V8 XJ Series/XK

211-06

## TECHNICAL BULLETIN

### Steering Rack Knocking Or Rattling – Revised Lower Steering Column/Rack Return Line – Repair Procedure

ILLUSTRATION 1

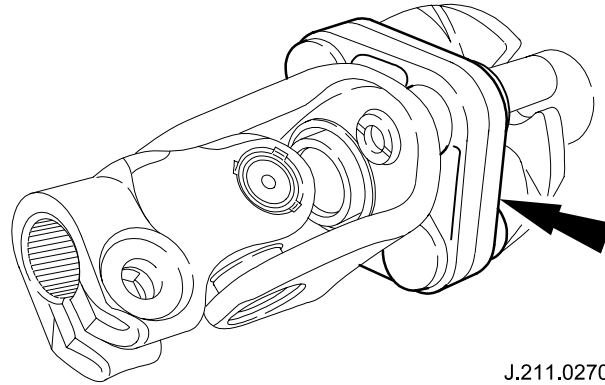
**Note:** The modified lower steering column has a rubber coupling (Illustration 1). If the modified lower column is present, **continue with PAS line installation only.**

On vehicles prior to VIN A11051 (XK Series) and VIN F20645 (V8 XJ Series), check to see if a modified lower steering column (modified lower steering column has a rubber coupling) has been retrofitted, if not, install a modified lower steering column and new steering rack return line.

**POWER STEERING RETURN LINE - XK**

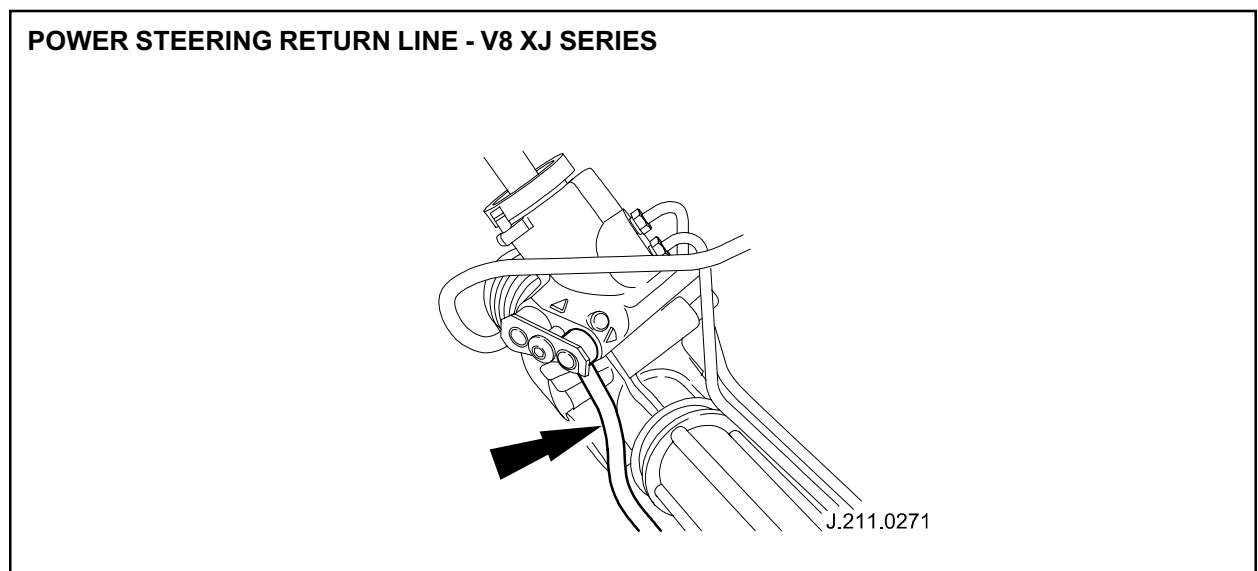
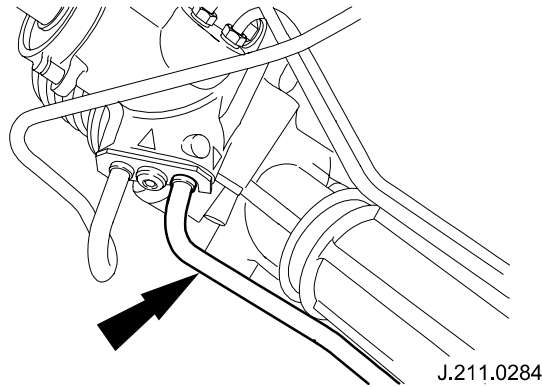
On vehicles after VIN A11051 (XK Series) and VIN F20645 (V8 XJ Series), or if a modified lower column has been retrofitted, install new steering rack return line only.

- Install PAS return line (see Workshop Manual, JTIS CD-ROM, section: 211-02, (SRO 57.15.30 for 1997-2000 MY vehicles).
